Location of underground conduit between BLDG #1 and the Parking Ramp. Location of pullbox in BLDG 1.

Proposed changes required to utilize existing conduit (fire alarm and feeder for BLH-2 swap conduits, add new divider to separate low voltage from high voltage):

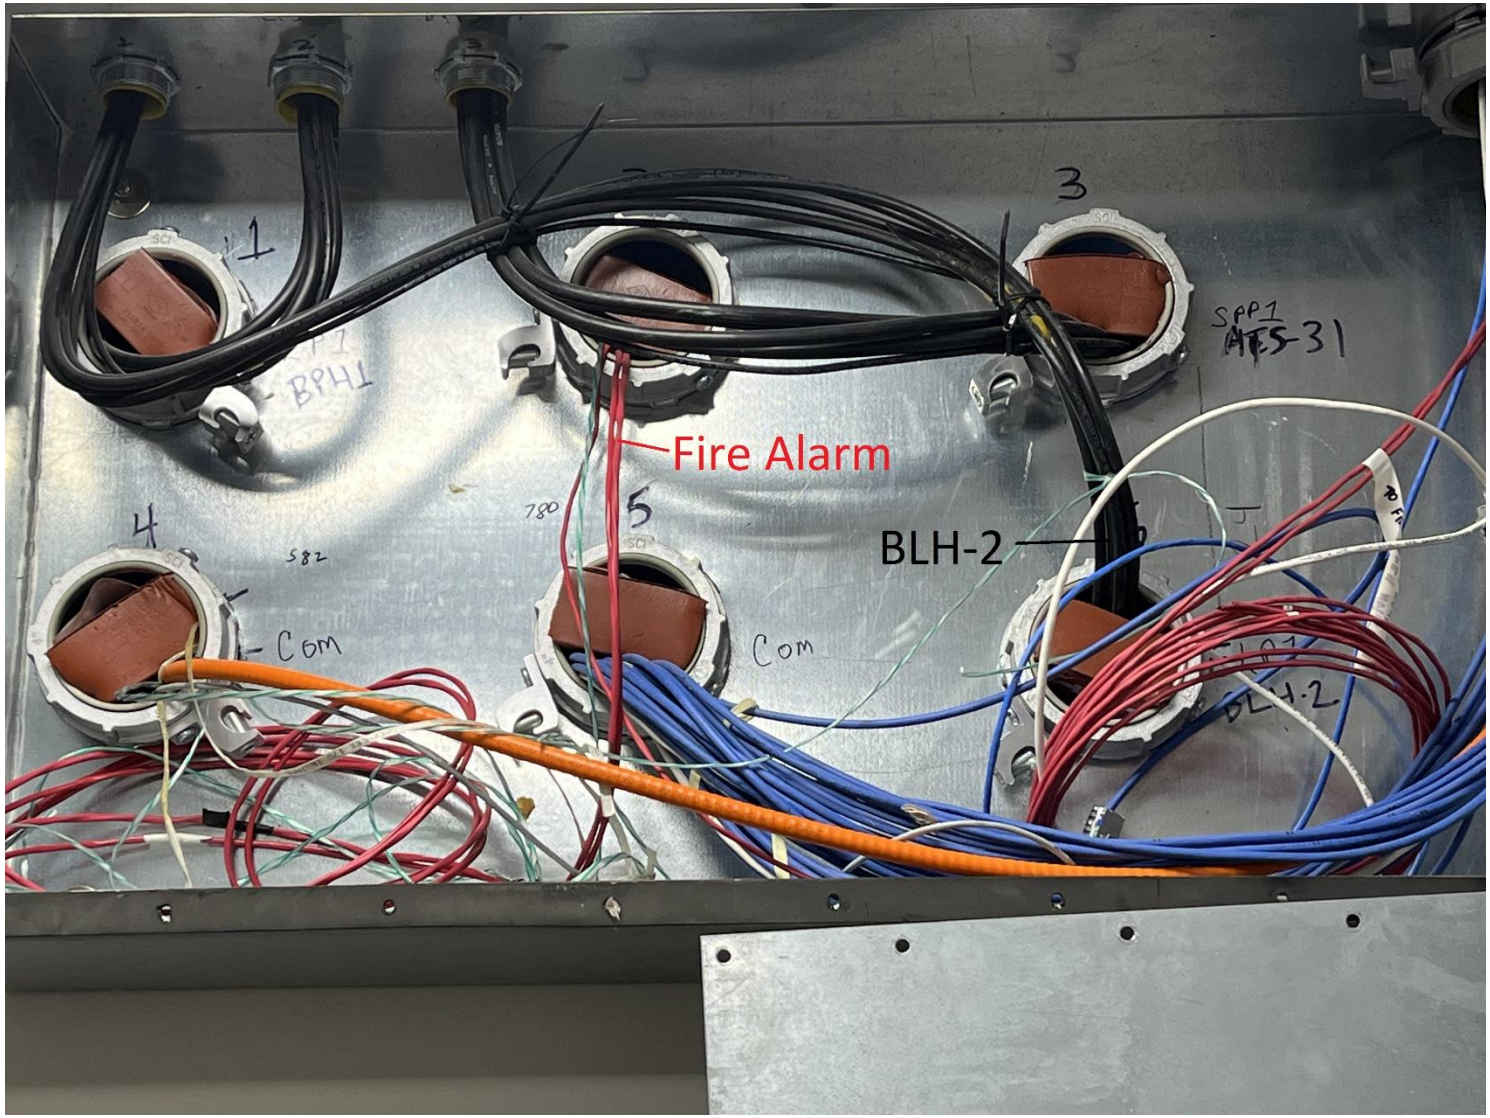
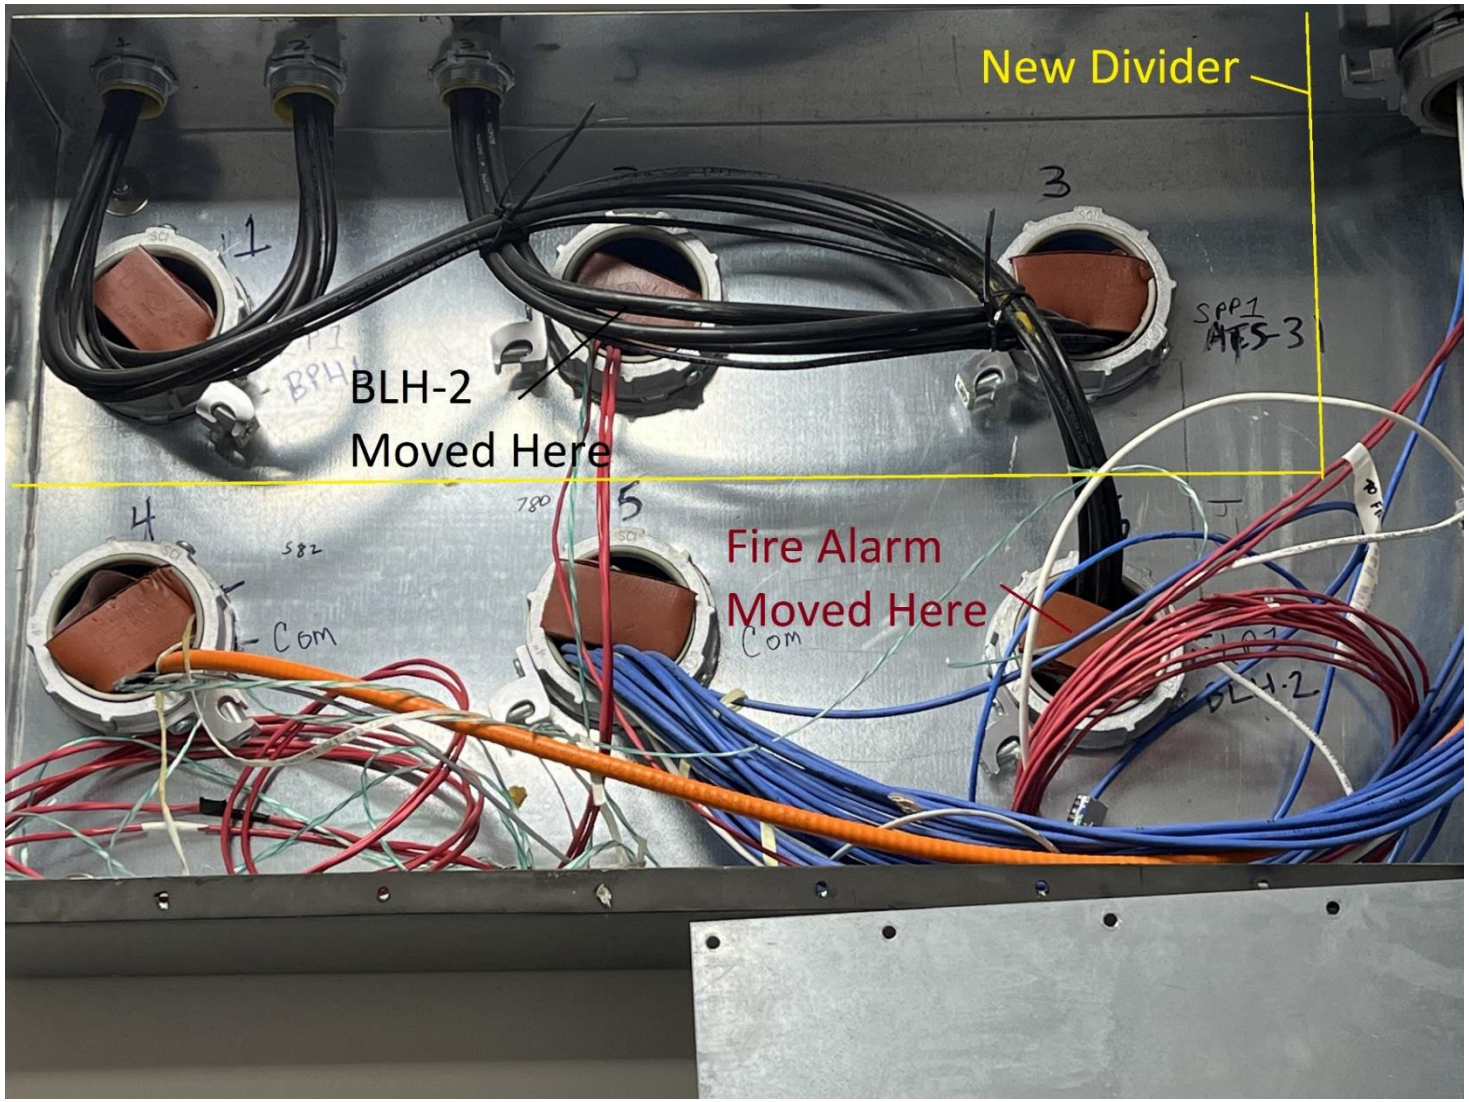
Existing Conditions showing existing fire alarm cable and feeder for panel BLH-2:

- Existing feeder cables for BLH-2: cables to be pulled out, and then pulled back in through the alternate conduit.

- Existing and fire alarm wire: to be pulled out, and then pulled back through the alternate conduit. Contractor shall coordinate with Simplex / Johnson Controls when disconnecting and reconnecting, including final connections and testing.

- Both the fire alarm cable and feeder for BLH-2 may be re-used, as long as the cables / wires are not damaged when pulled back out.

- Swapping BLH-2 and fire alarm conduits will require outages. Outages and pulling wire / cable will need to occur outside of normal operating hours, or over weekends, as approved by the VA. All outages are required to be coordinated with the VA a minimum of 30 days in advance of the outage.

- Contractor is responsible for providing labels on the cover of the existing pullbox located in room E-10. Labels shall read ‘fiber optic’, ‘Fire Alarm’, ‘Data’, ‘High Voltage’, ‘High Voltage’, ‘High Voltage’. Contractor to secure labels to the cover to identify the location and type of cabling / wires. Labels shall be1 /16" thick plastic engraved acrylic plates or VA approved equal. Labels shall be positively secured to covers.

Proposed new disconnect and junction box configuration:

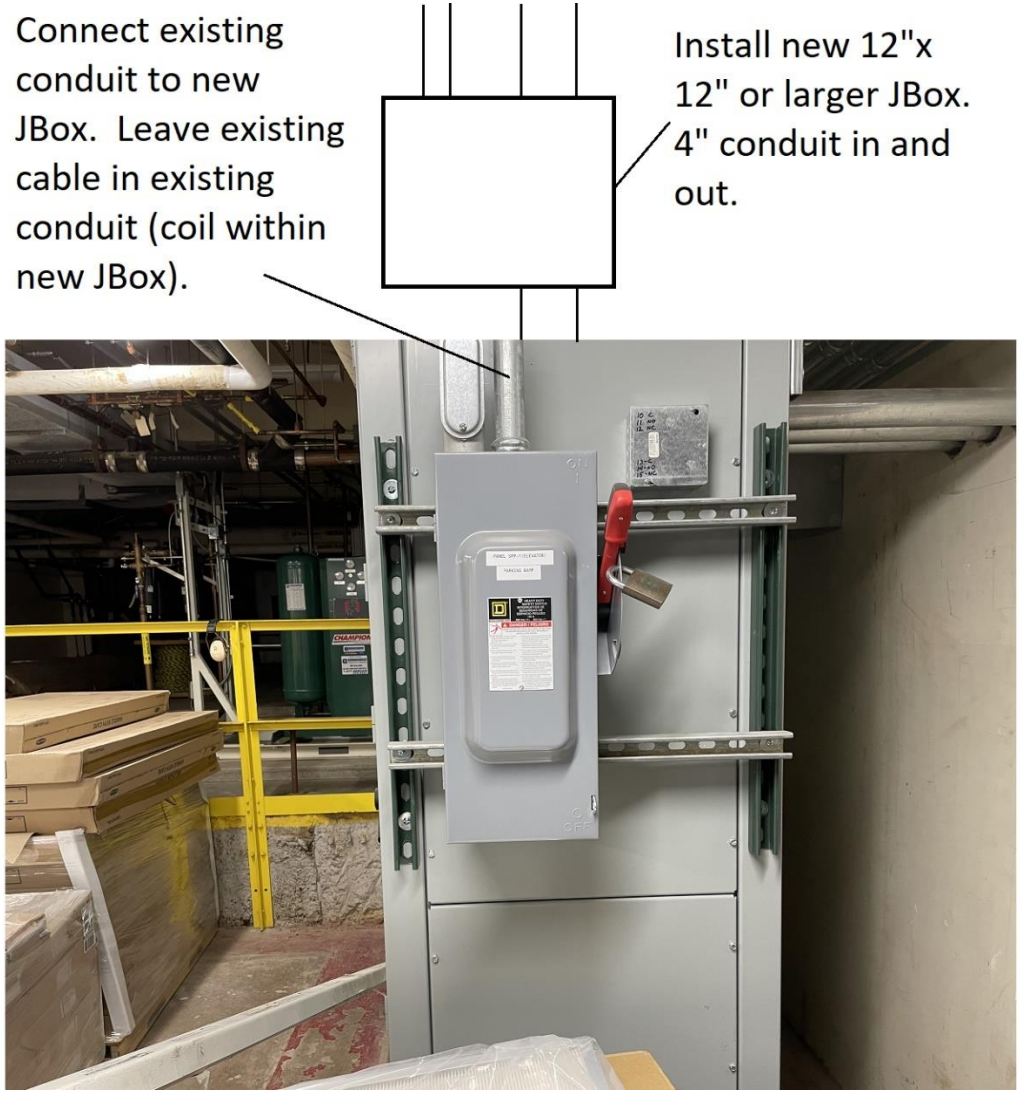
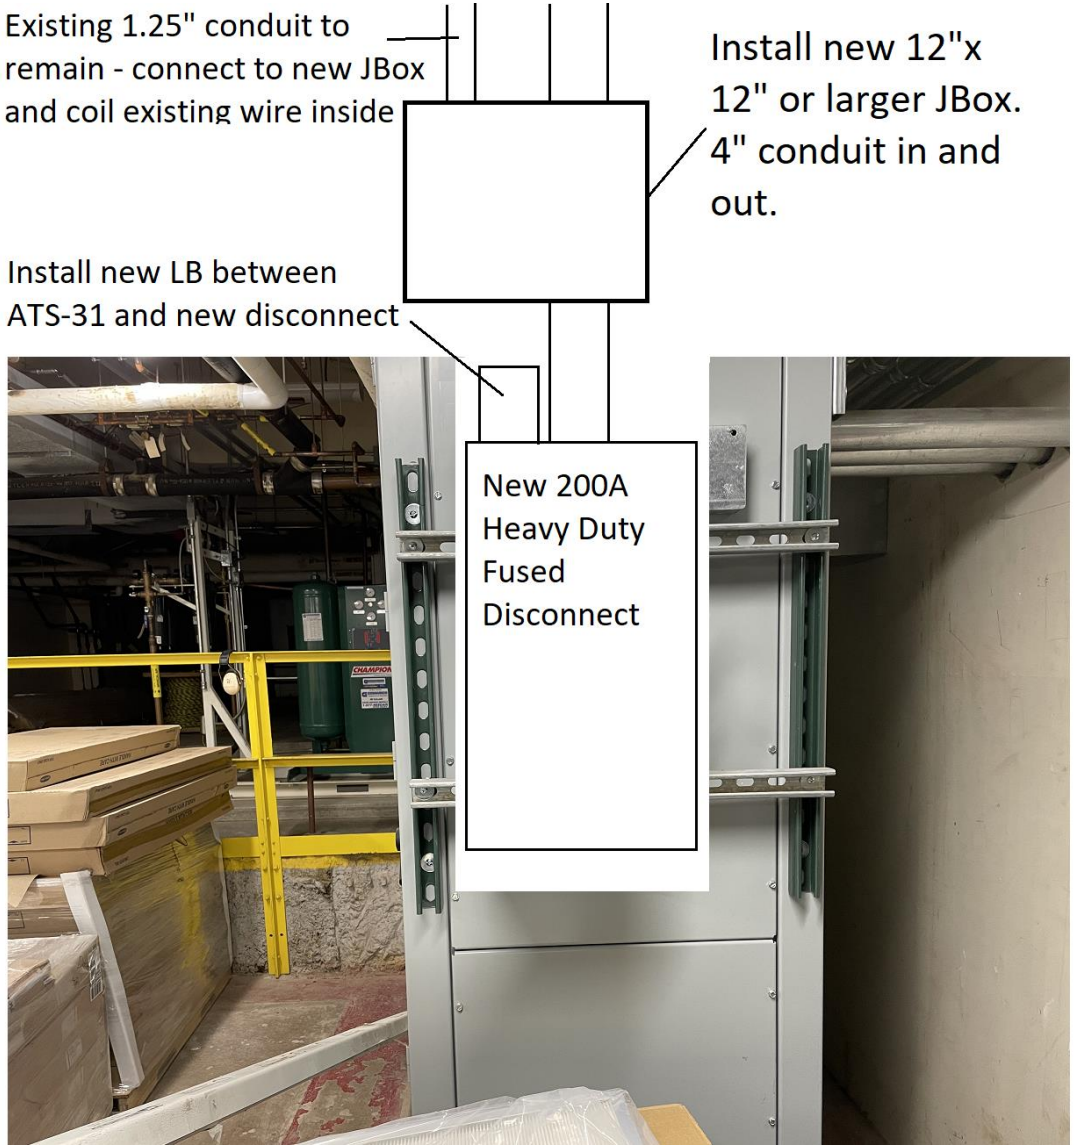
Remove existing 100A disconnect and install new 200A heavy duty fused disconnect on existing unistrut. Connect new 4” conduit.

Install new junction box above new 200A heavy duty fused disconnect:

Panel SPP-1 in existing parking ramp electrical room (to be removed – refer to project electrical drawings):

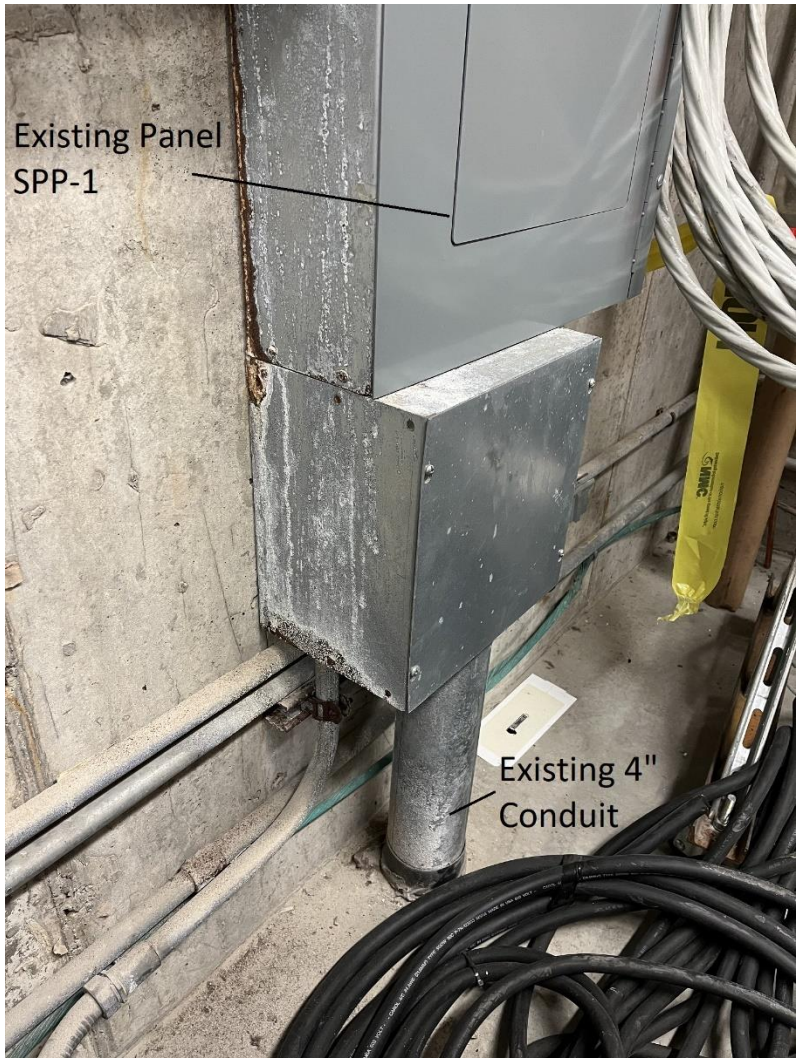
Panel SPP-1 to be removed and replaced with a new panel – extend 4” conduit to new panel:

- New electrical panel SPP-1 shall not be mounted directly to concrete walls within the existing electrical room. Panel shall be mounted on galvanized or stainless steel mounting brackets, such as Unistrut.
